Project	IEEE 802.16 Broadband Wireless Access Working Group < http://ieee802.org/16 >	
Title	Revision of Hand-over Mechanism for Mobility Enhancement	
Date Submitted	2004-01-02	
Source(s)	Phillip Barber Broadband Mobile Technologies, Inc. 8302 Sebastian Inlet Frisco, Tx 75035	Voice: +1 (972) 365-6314 Fax: +1 (925) 396-0269 [mailto:pbarber@BroadbandMobileTech.com]
Re:	Response to IEEE 802.16e-03_58 (Call for Contributions on IEEE 802.16e/07r5)	
Abstract	Revision of Hand-over Mechanism for Mobility Enhancement	
Purpose	Stimulate discussion on a more completely defined, flexible model and mechanism for facilitating mobility functionality	
Notice	This document has been prepared to assist IEEE 802.16. It is offered as a basis for discussion and is not binding on the contributing individual(s) or organization(s). The material in this document is subject to change in form and content after further study. The contributor(s) reserve(s) the right to add, amend or withdraw material contained herein.

Revision of Hand-over Mechanism for Mobility Enhancement

Observations on Current IEEE 802.16e-03/07r5 Based on Criteria from Assumptions

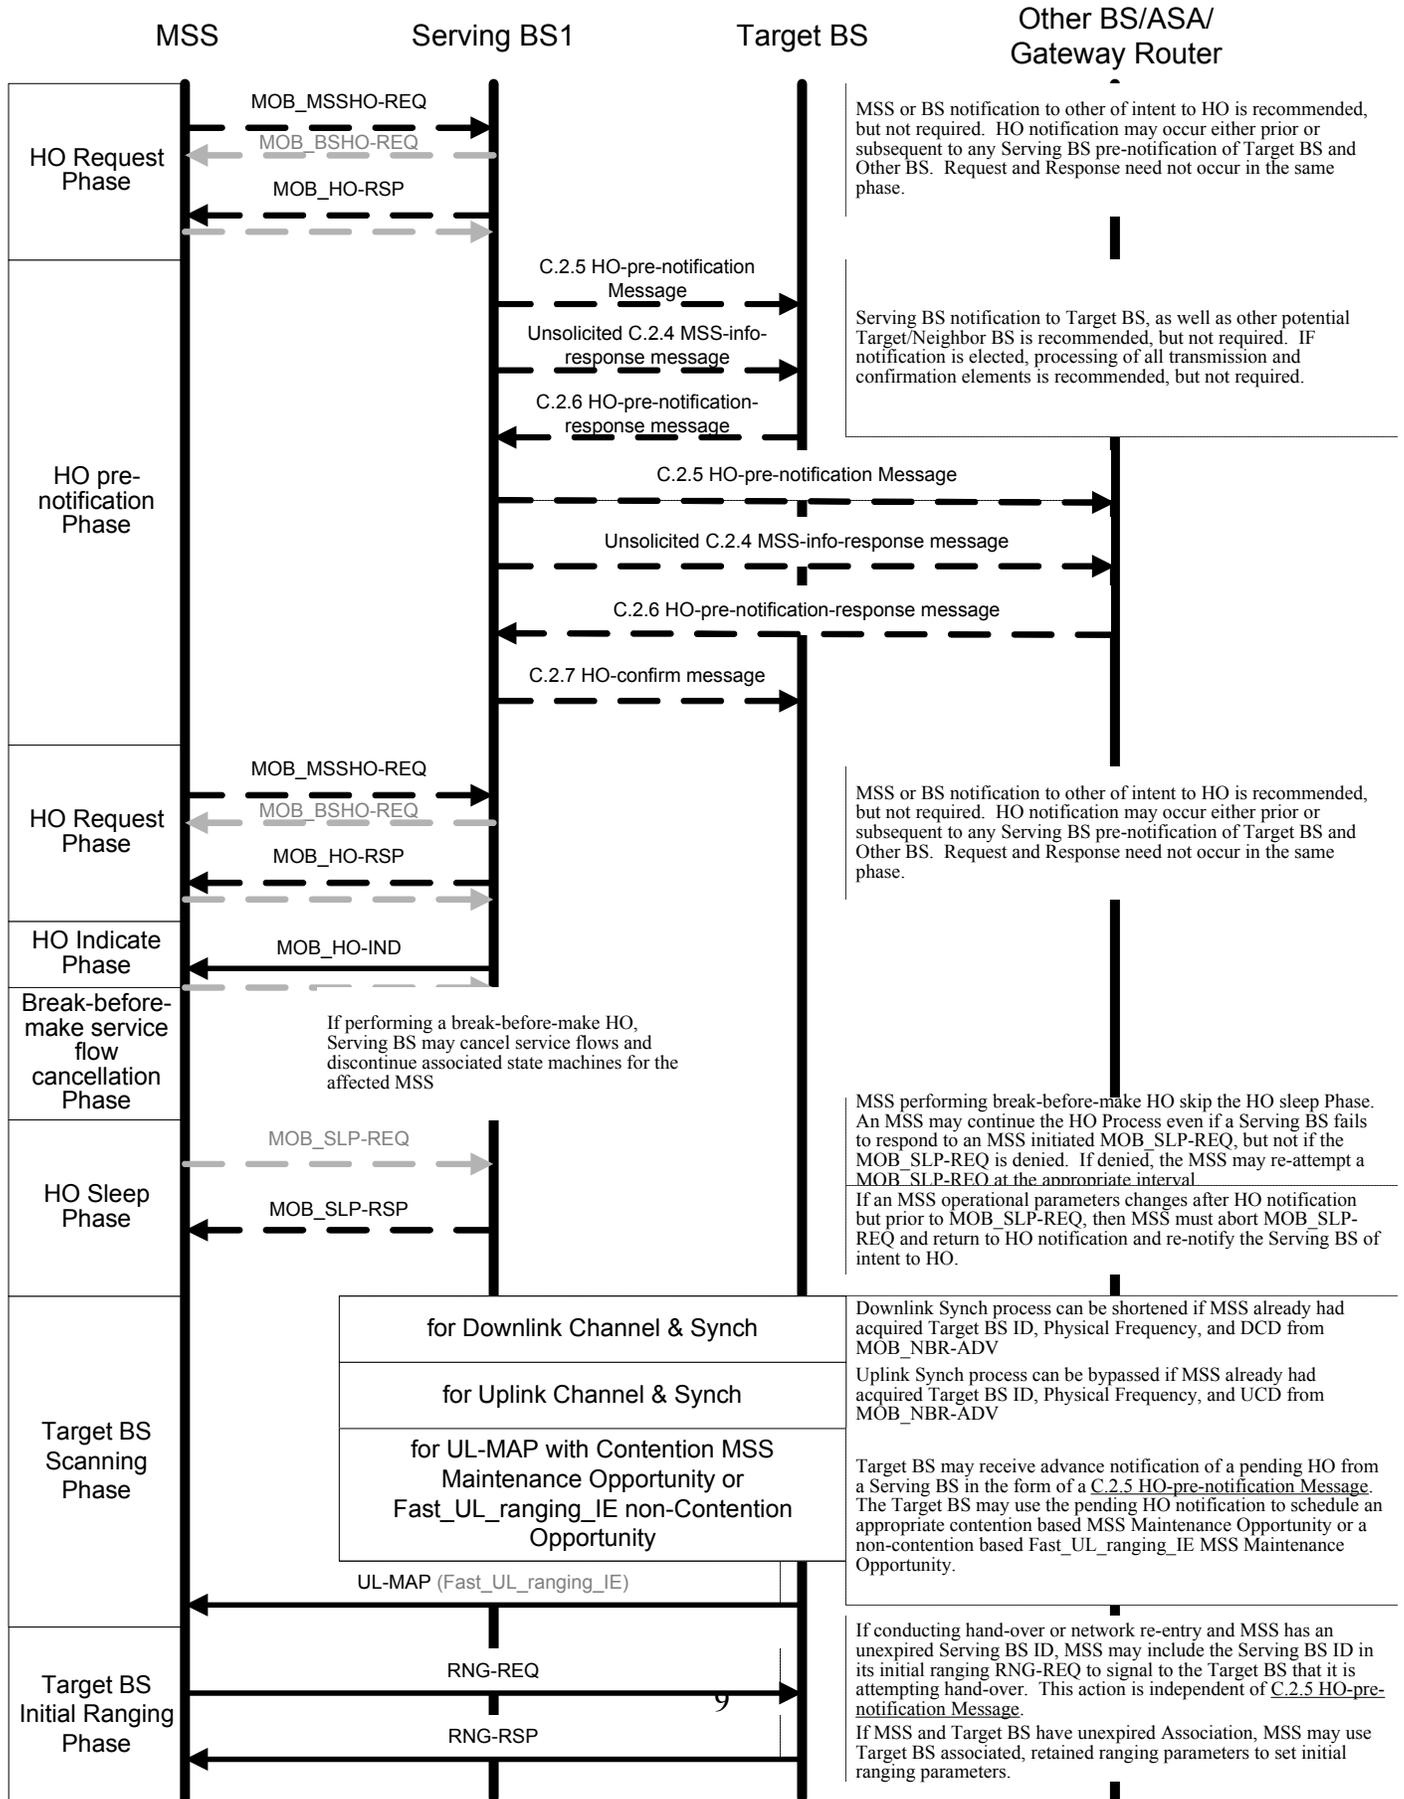
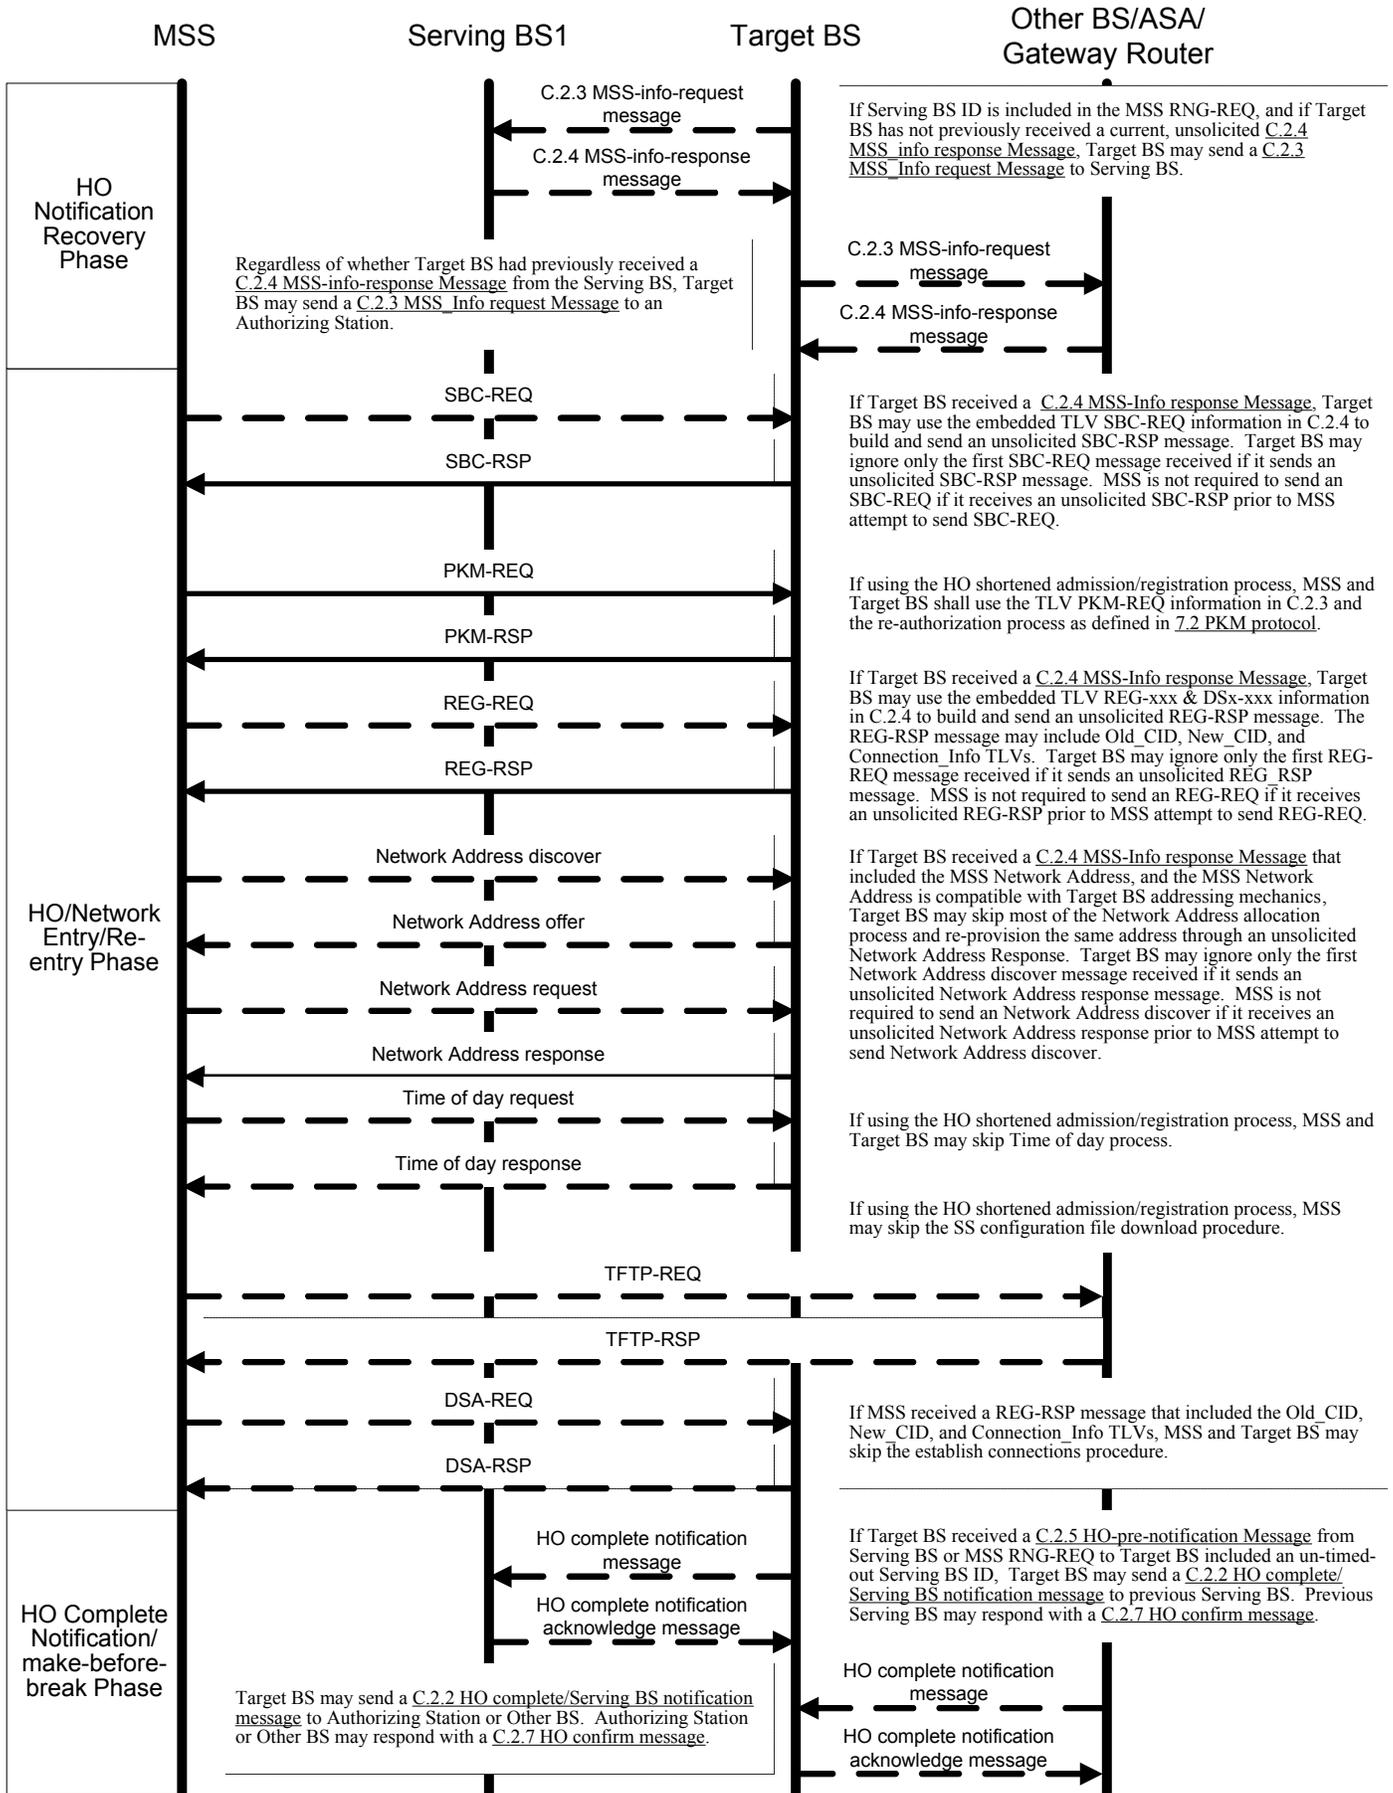
Remedy Action 15:

[In C.2.8 Example of Backbone Network HO procedure, pages 54-56, delete Figure C.2—Example of HO call flow by BS entirely and replace Figure C.1—Example of HO call flow by MS with:]
